National Committee on Uniform Traffic Control Devices

National Committee on Uniform Traffic Control Devices (NCUTCD) Recommended Changes to Proposed Text for 11th Edition of the MUTCD Docket Number: FHWA-2020-0001

NPA MUTCD Section Number: Chapter 4L

Figure 4L-1. Example of RRFBs at Uncontrolled, Marked Crosswalks at an Intersection

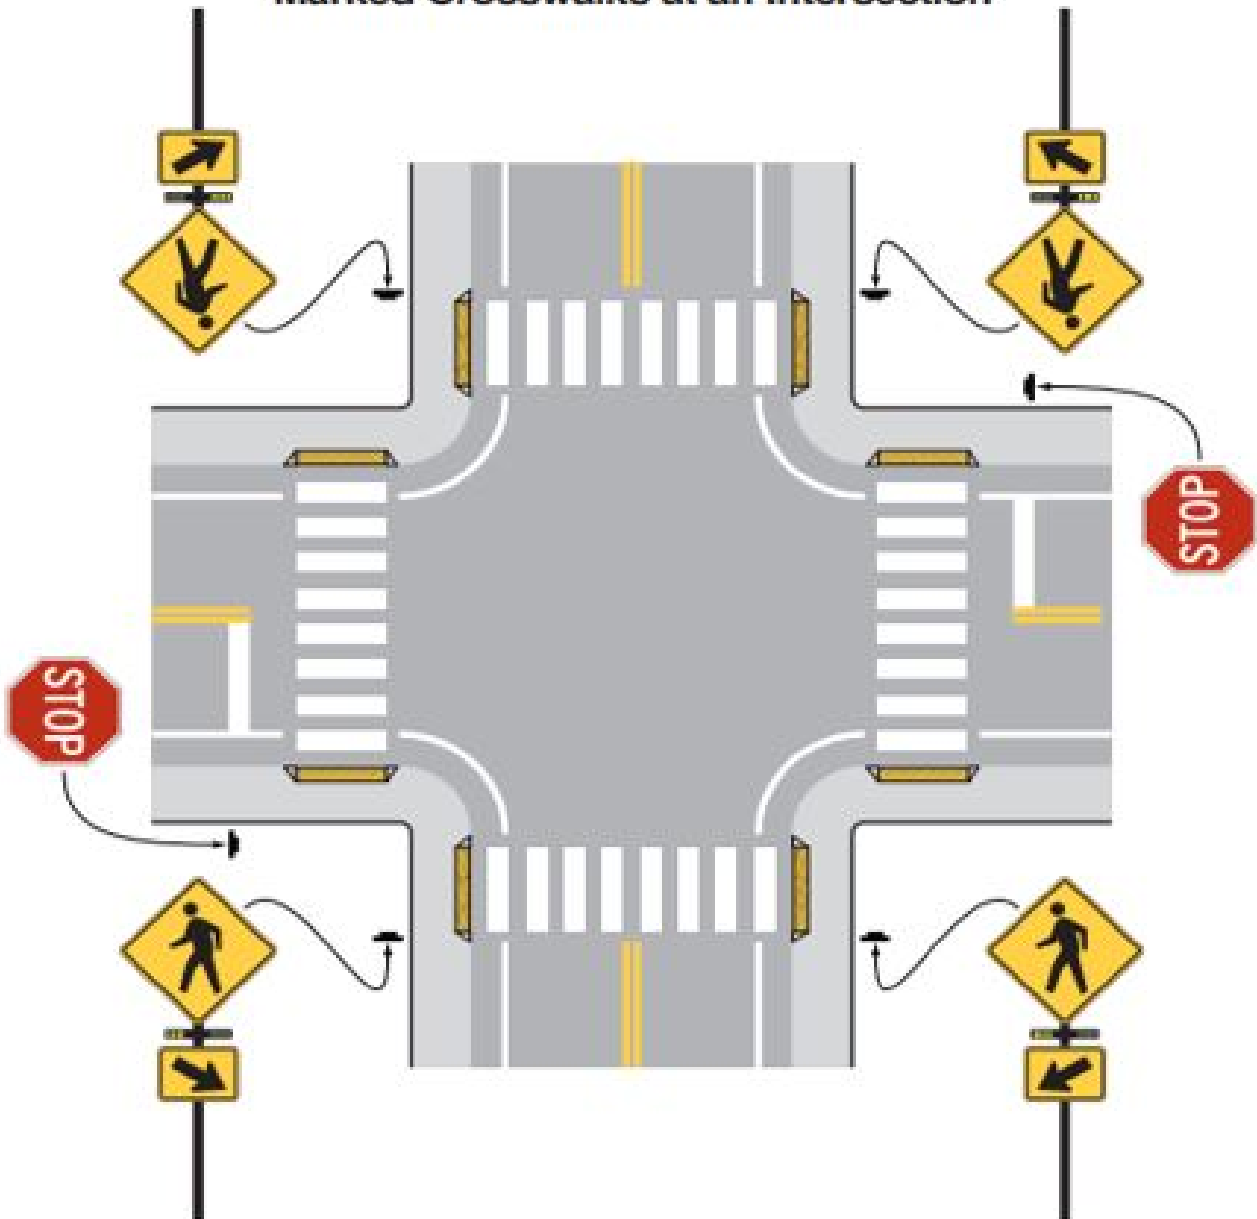
98 If used at intersections with two crosswalks on an uncontrolled approach, post-mounted
99 RRFBs may be installed to face only one direction of travel at the first crosswalk that traffic
100 encounters (see Figure 4L-1).

1. When activated, the RRFBs on both approaches shall simultaneously commence operation of their rapid flashing indications and shall cease operation simultaneously.
2. If placed overhead, follow the requirements of Section 4L.02 paragraph 07, except that the signs may be placed approximately over the center of the intersection.
